# Technical Service Bulletin

## 66 Wheel arch trim on front fender loose

66 22 91 2067881/1 August 30, 2022.

*Figure 3. Front wheel arch trim with retaining clip grommet damaged.*

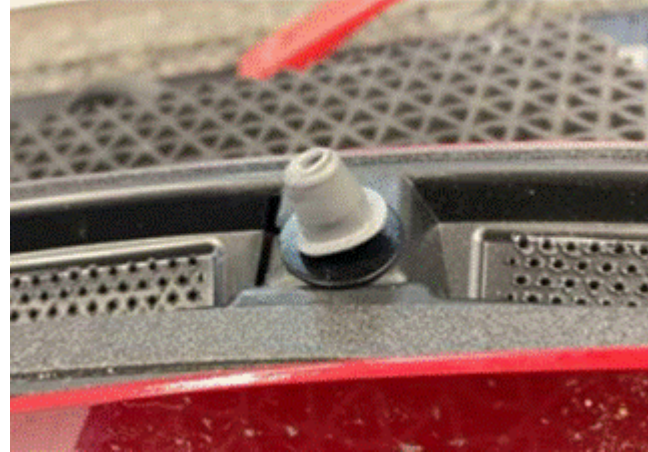
When the front wheel arch trim is removed damage to the female clip grommet is apparent (Figure 3).

Figure 4. Front wheel arch trim removal.

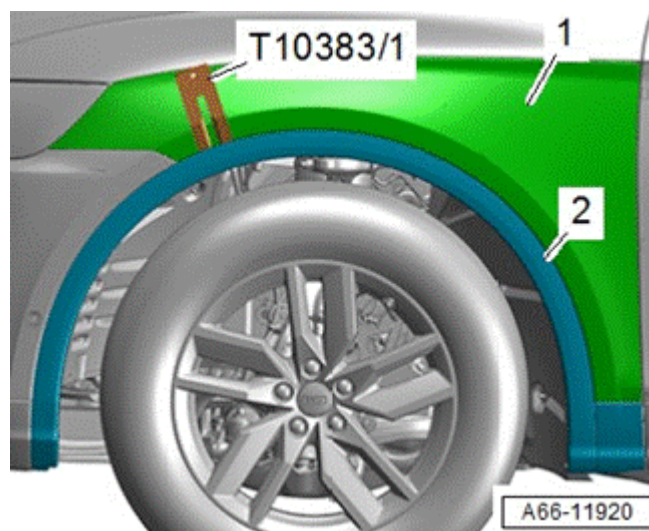
1. Using the T10383 wedge set remove the front wheel arch trim (Figure 4).

Figure 5. Front wheel arch trim clip location.

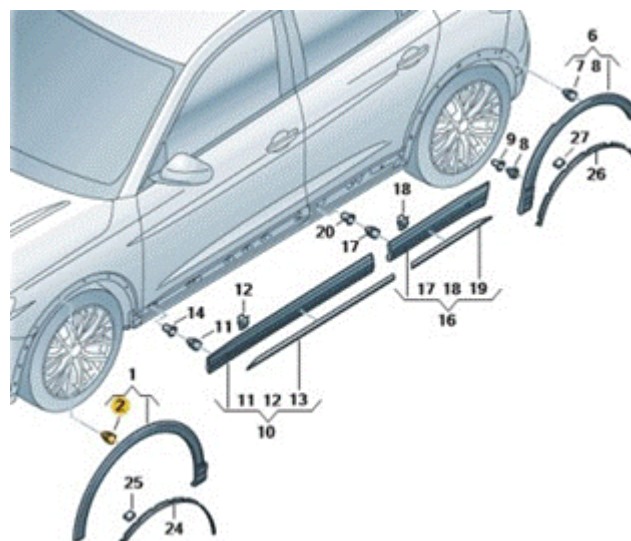
2. Replace all of the clips on the affected front wheel arch trim. The wheel arch trim does not need to be replaced (Figure 5).
